**TCRA FOR THE EXPERIMENTAL SHIP SHIELDING RANGE
BCT MEETING, FEBRUARY 23, 2012**

Action Memorandum RTCs Site Characteristics

Plan for Potentially Residual Contamination

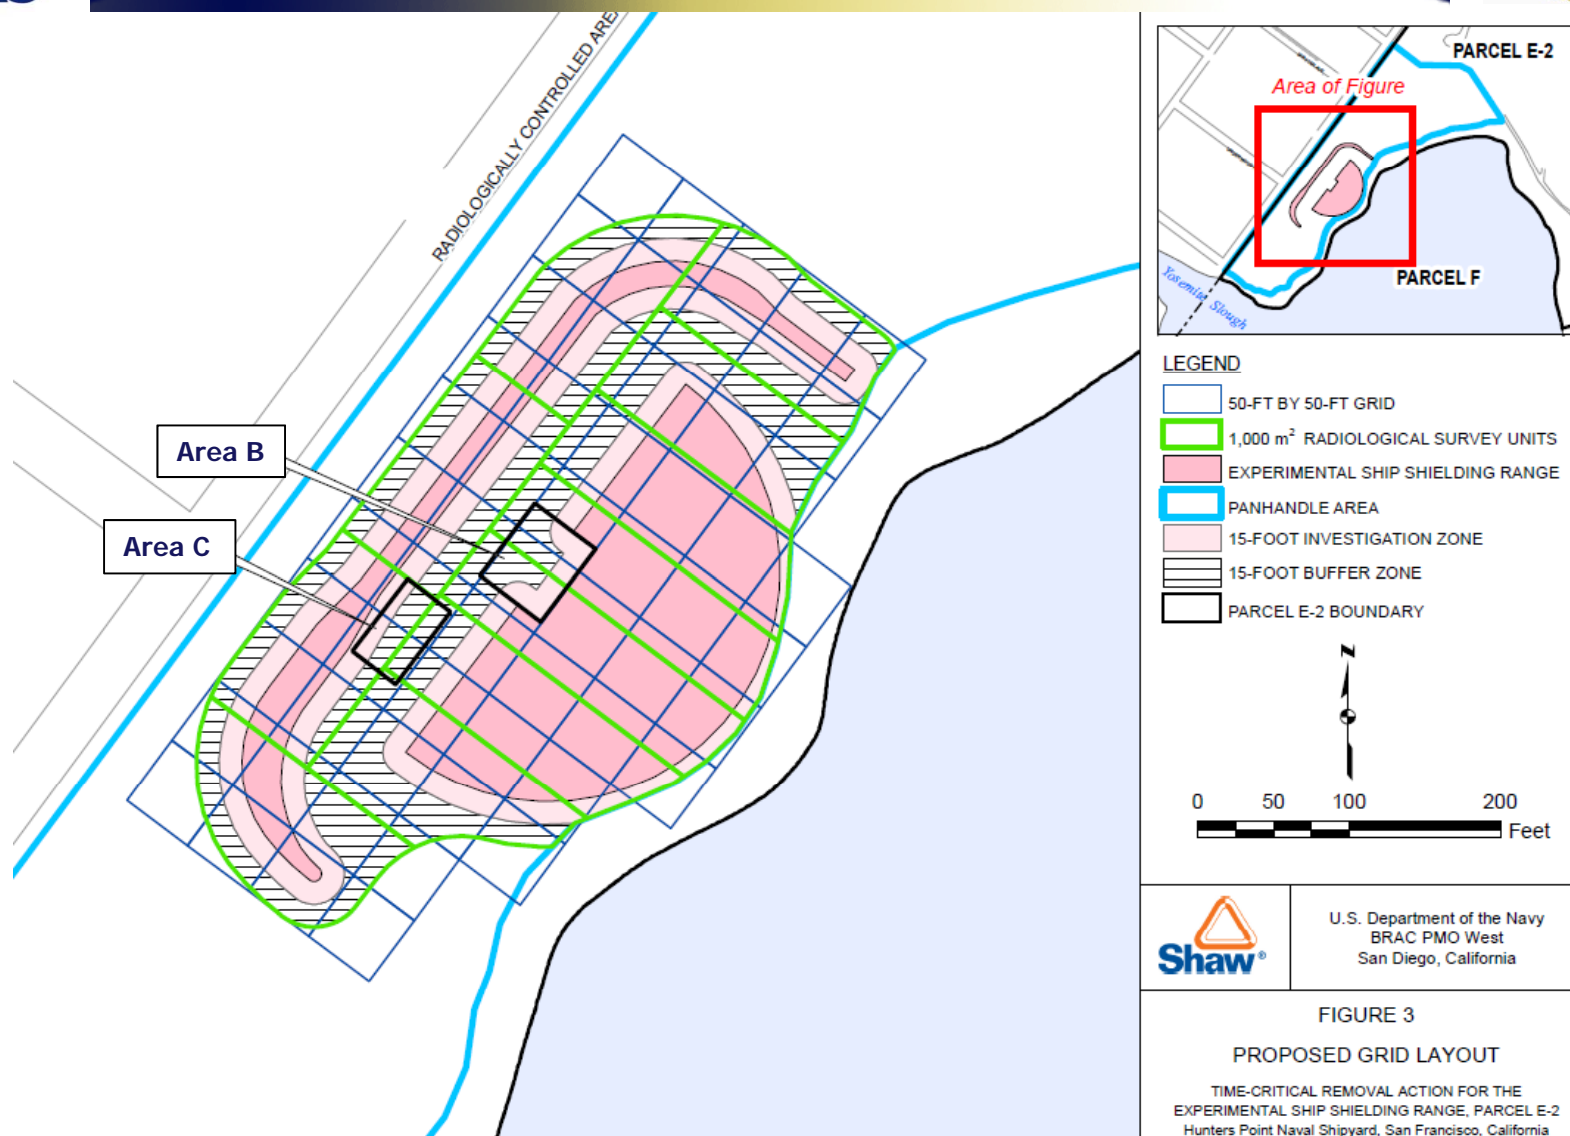
- The maximum excavation depth proposed will be 1-ft bgs even if residual radioactivity remaining exceeds the 60Co radiological release criteria based on confirmation soil samples/scan data. After "hot spots" are documented...how will these locations be addressed in the future?

- If confirmation samples require step-out excavation into the buffer zone (shown on Figure 2), will the Navy continue soil excavation/removal or will the Navy suspend work and address any additional cleanup work under the Parcel E-2 ROD remedial action?

- Because this is a TCRA for the removal of one site-specific radionuclide of concern (cobalt-60), there are no other contaminants of concern (COCs) or project action limits established in the Action Memorandum for the Shielding Range. Cesium-137, radium-226, and strontium-90 will be cleaned up within the bounds of the Shielding Range to 1-ft bgs in accordance with currently established radiological release criteria (Table 1).
- Cobalt-60 step-outs will be addressed under this TCRA. If confirmation samples indicate presence of any other ROC, this TCRA will address removal of discreet point sources; however, if step-outs for other ROCs extend beyond the buffer zone, they will be documented and the location surveyed.
- A FCS will be conducted to document as-left-conditions. Residual contamination will be addressed in the final remedial action for Parcel E-2.
